BARANGAROO SOUTH

Stage 1B Public Domain Modification S4.55 Development Application Report

Mod Application Overview

FORMER SPIRIT OF TASMANIA
LOADING DOCK DETAIL PLAN

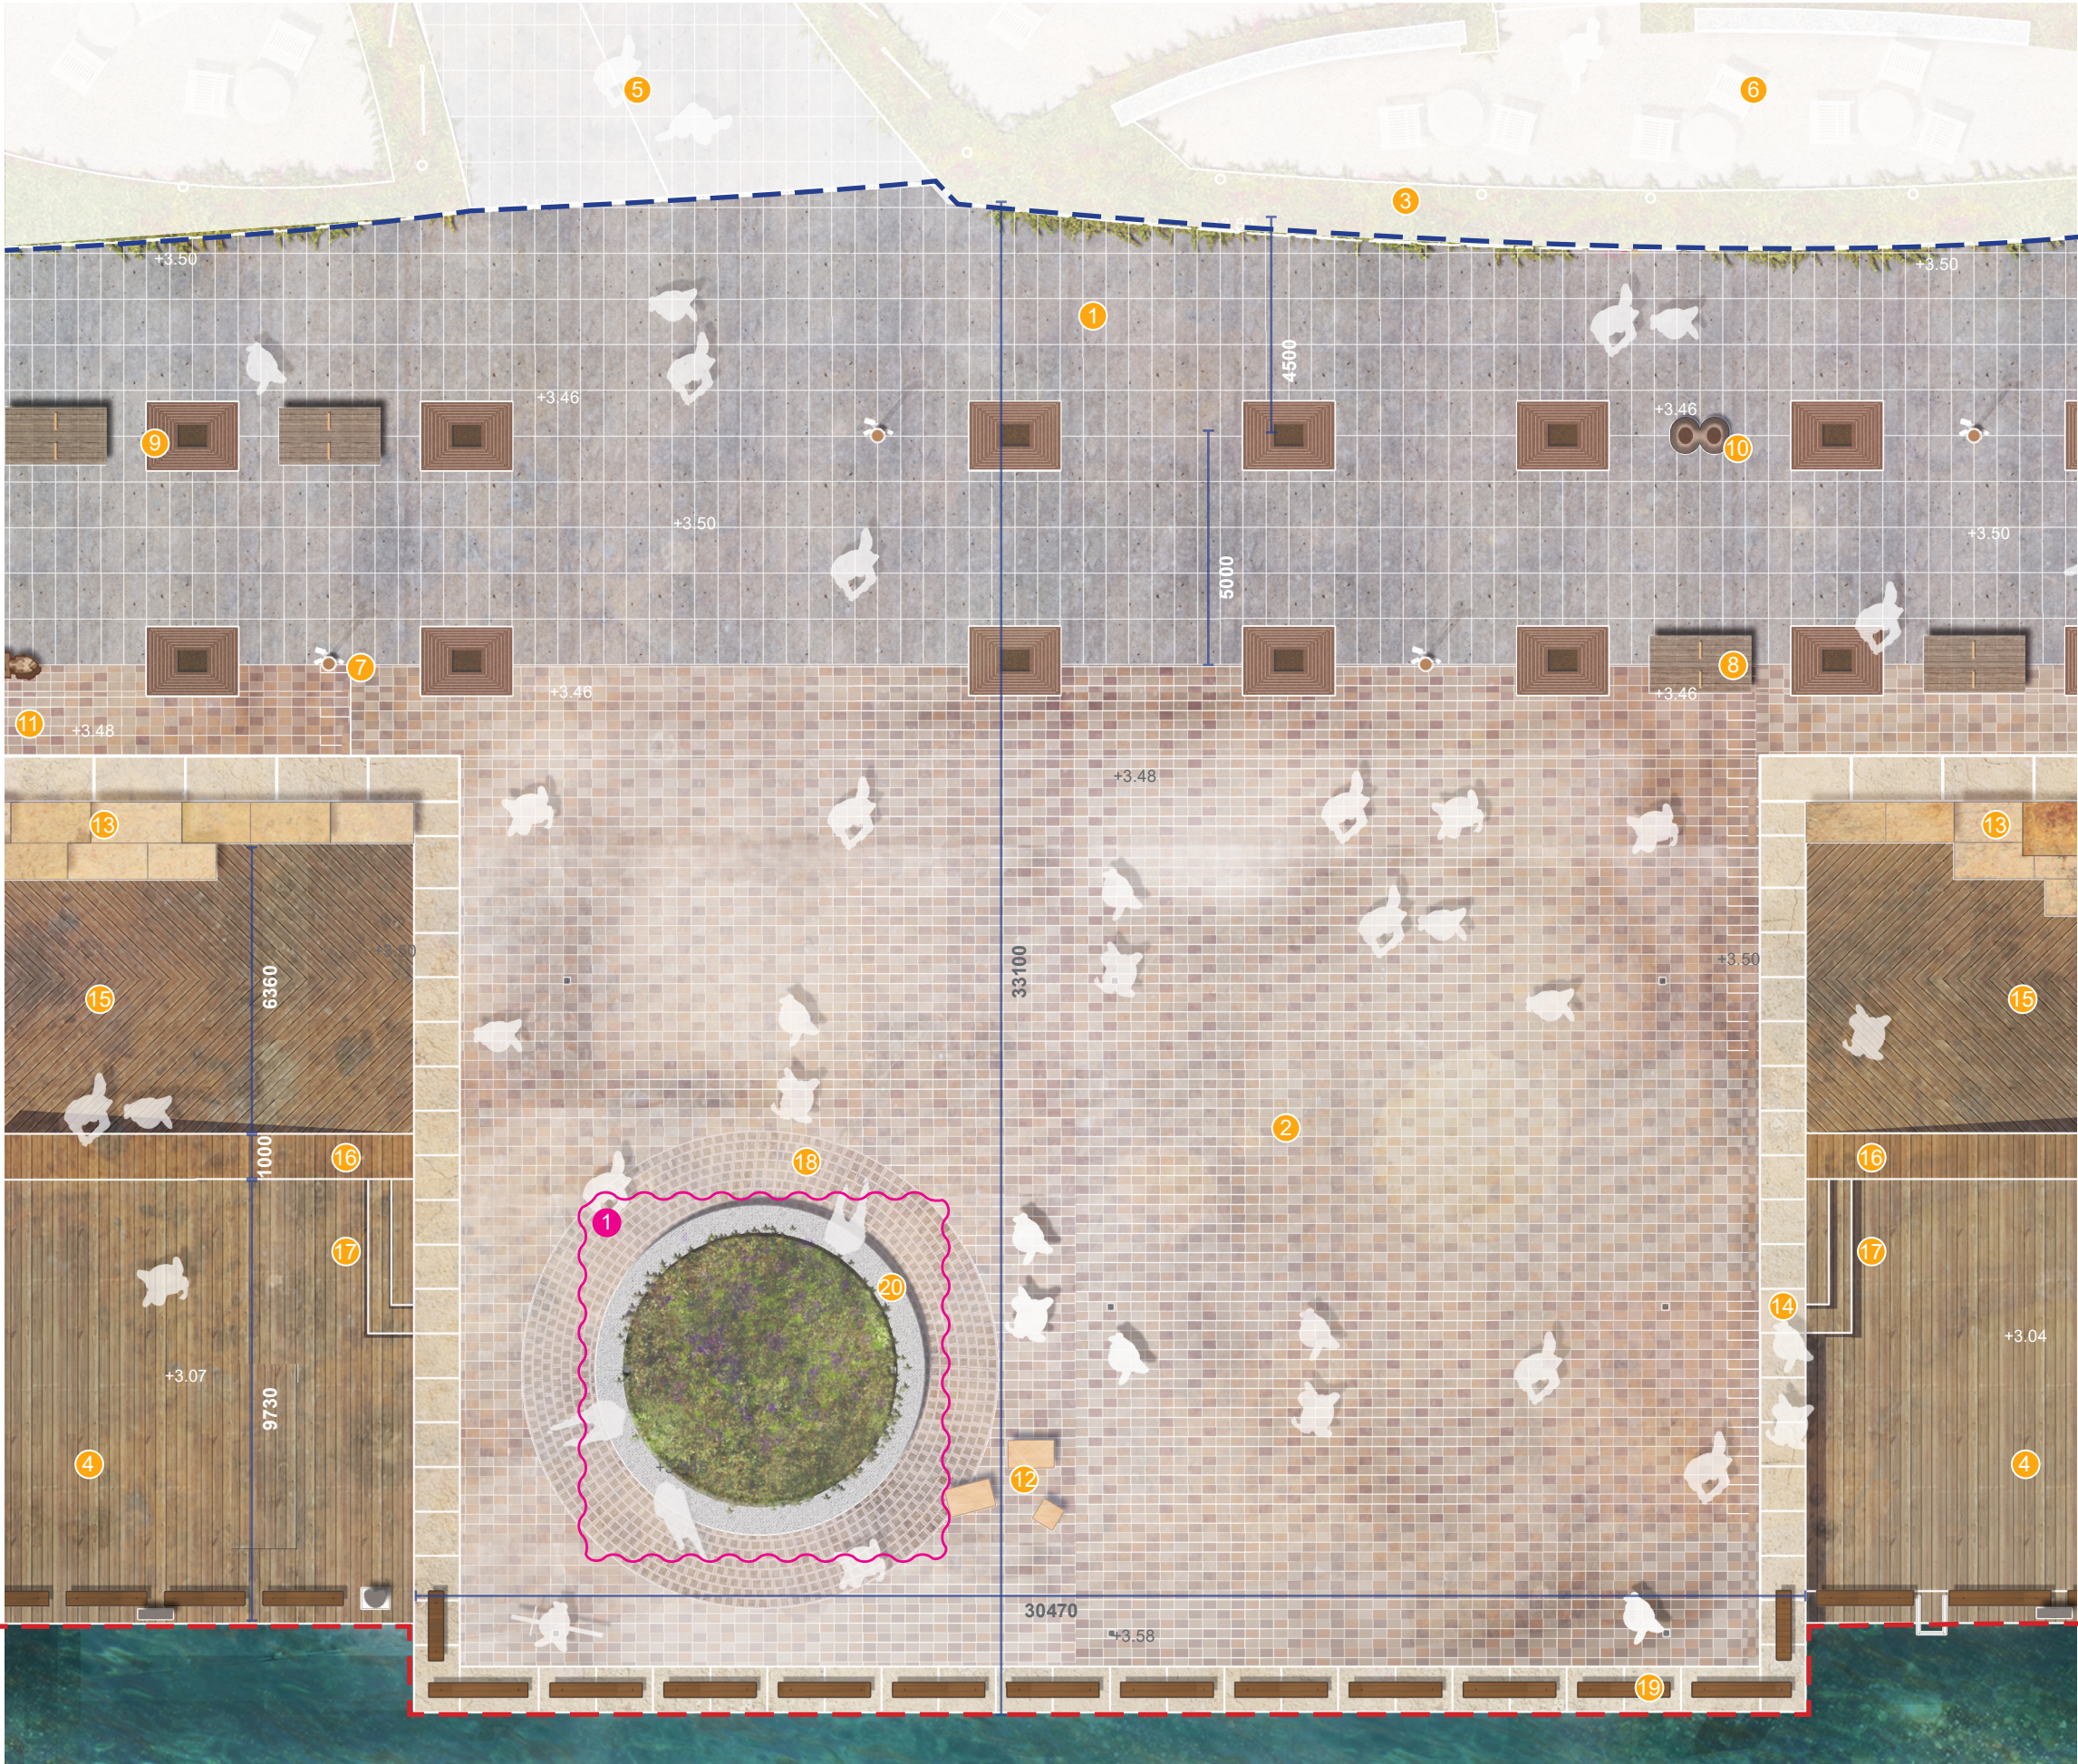
- Amendment cloud
- 1 Remove timber top for Sprit of Tasmania
loading dock raised planter seating

FORMER SPIRIT OF TASMANIA LOADING DOCK DETAIL SECTION

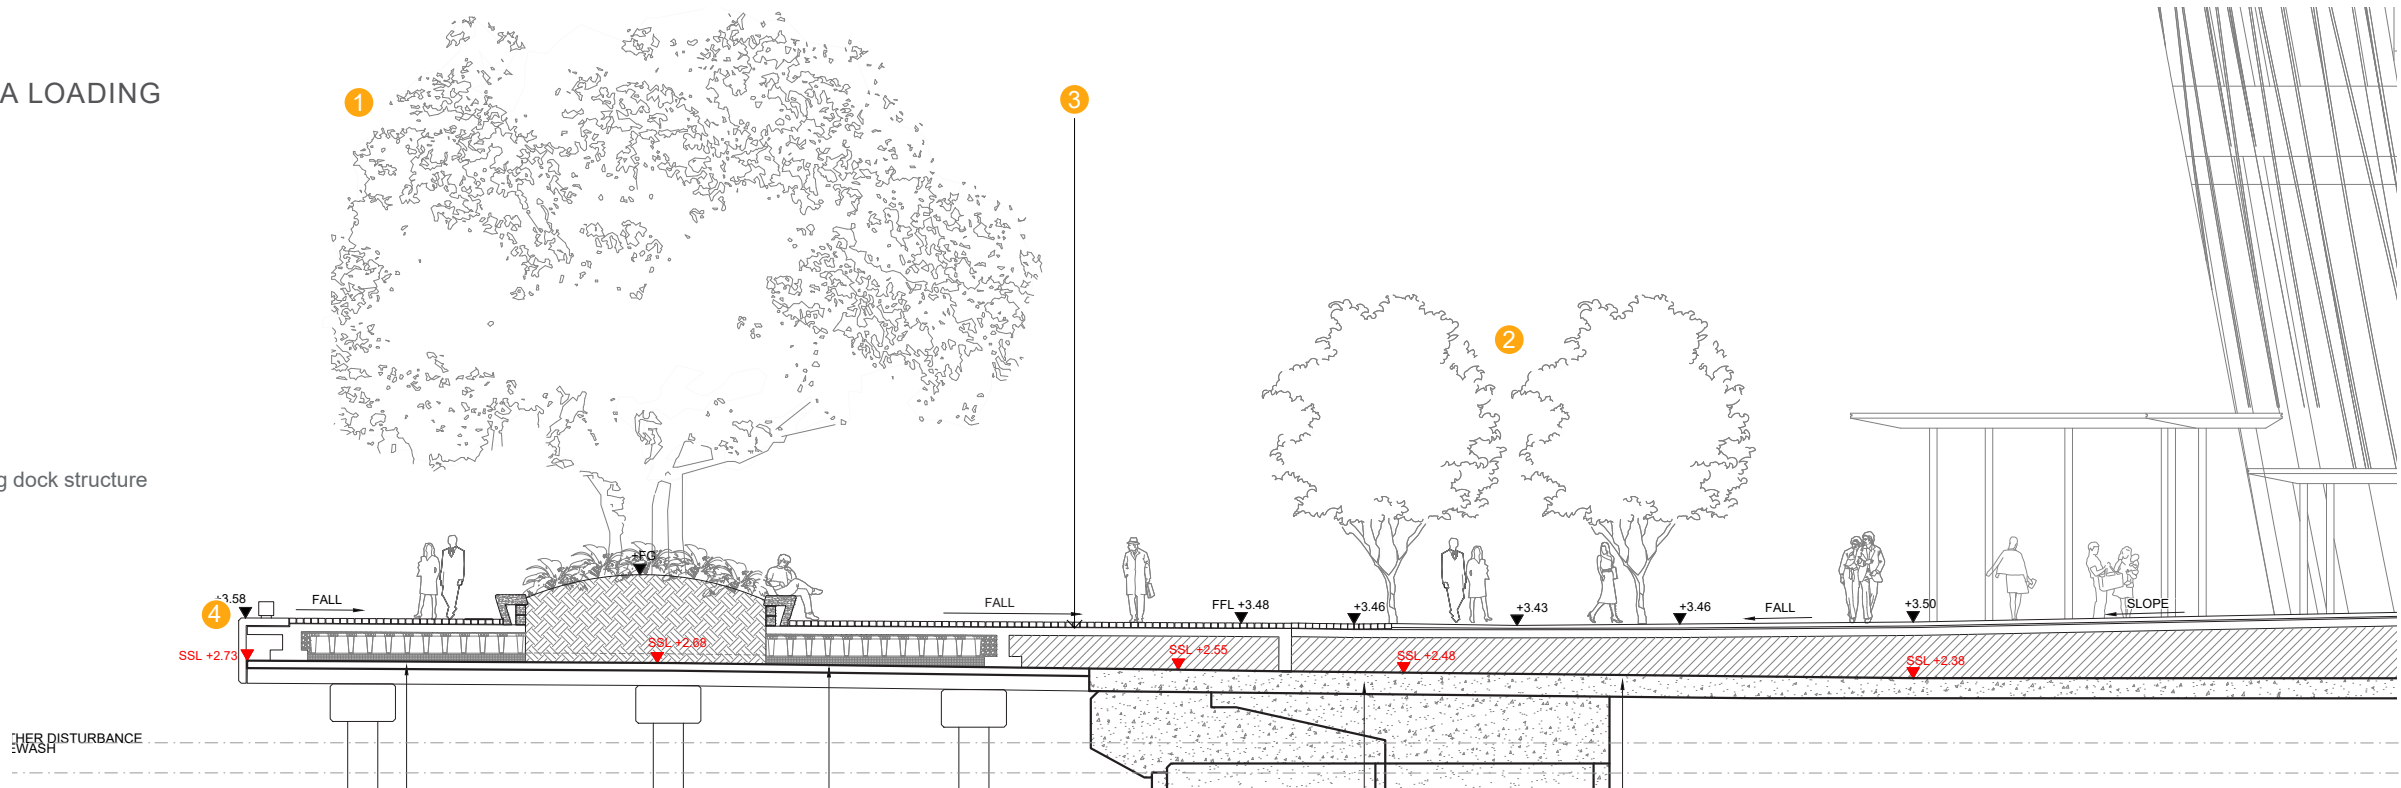
- Amendment cloud
- 1 Remove timber top for Sprit of Tasmania loading dock raised planter seating

WATERMANS COVE MASTER PLAN

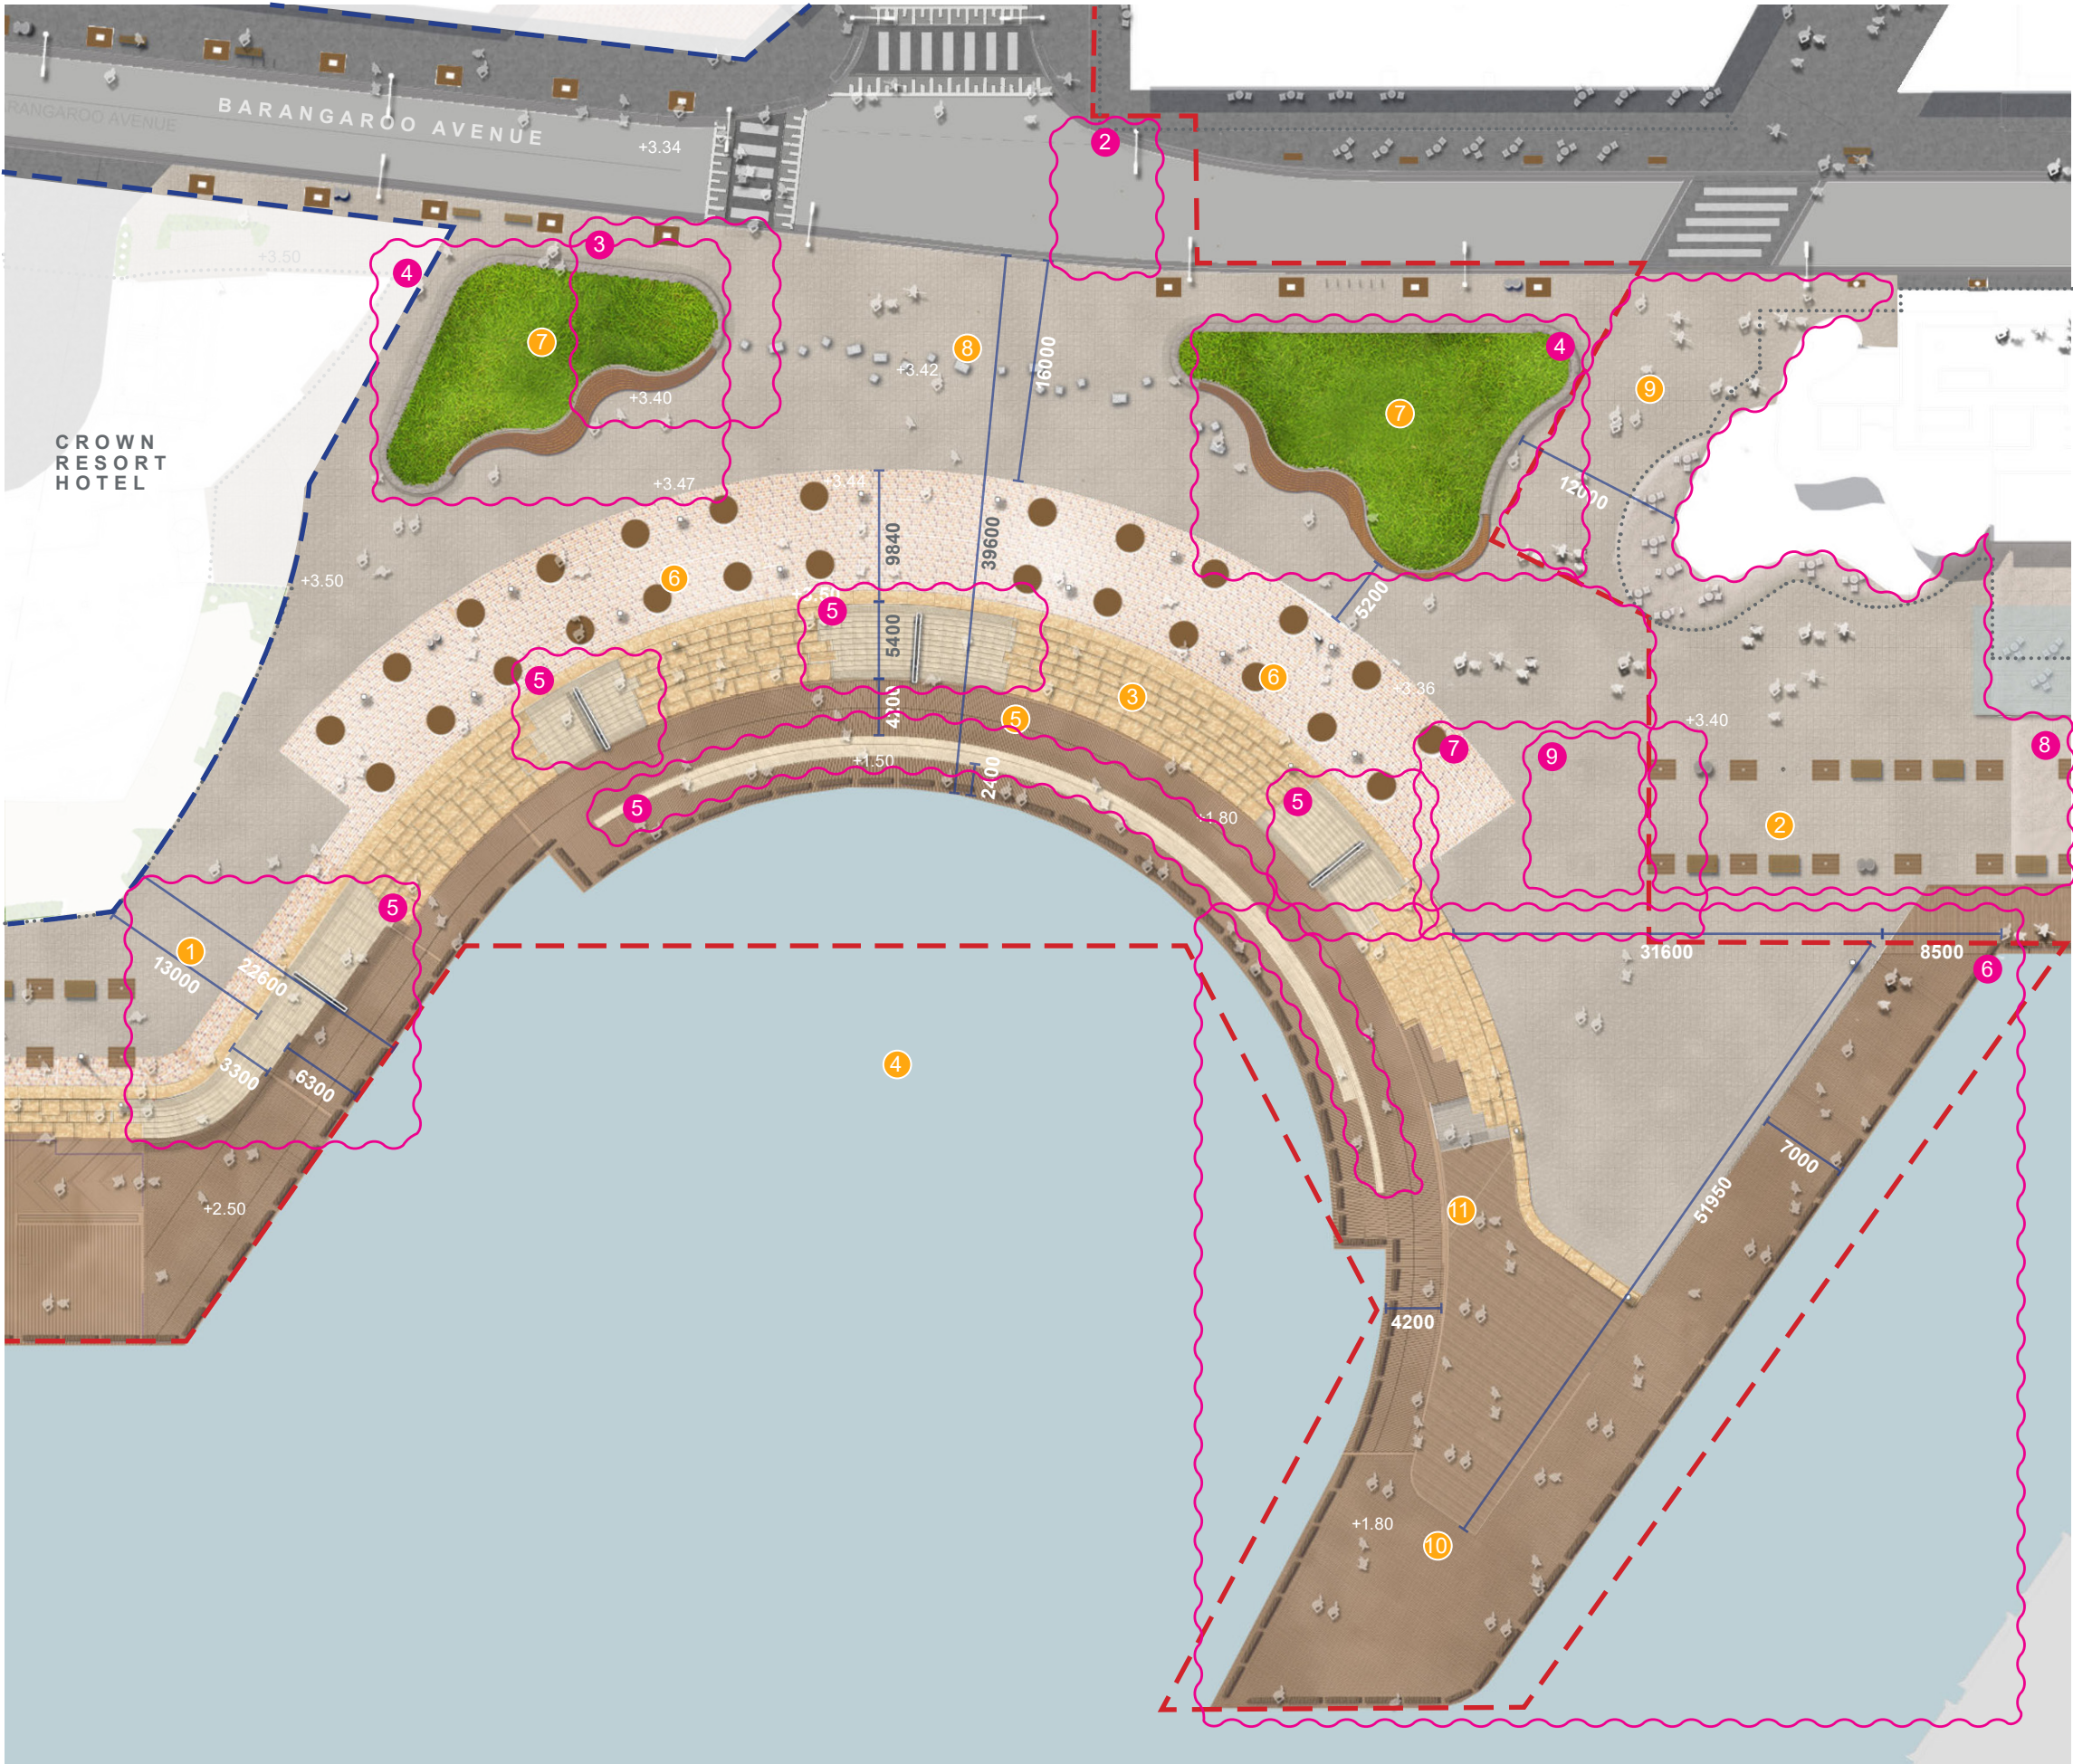
- Amendment cloud
- 1 Not in use
- 2 Deletion of pedestrian crossing
- 3 Relocated Fig tree to North raised planter
- 4 Change geometry of raised planter/reduce raised planter timber top and remove timber backrest
- 5 Stone stairs changed to concrete
- 6 Pier re-design: change to 3 tiers design
- 7 Stop porphyry paving at the top of the last Southern stair
- 8 Stage 1A design modification to suit Stage 1B proposal. Subject to seperate approval.
- 9 Remove 2no. trees adjacent to Stage 1A
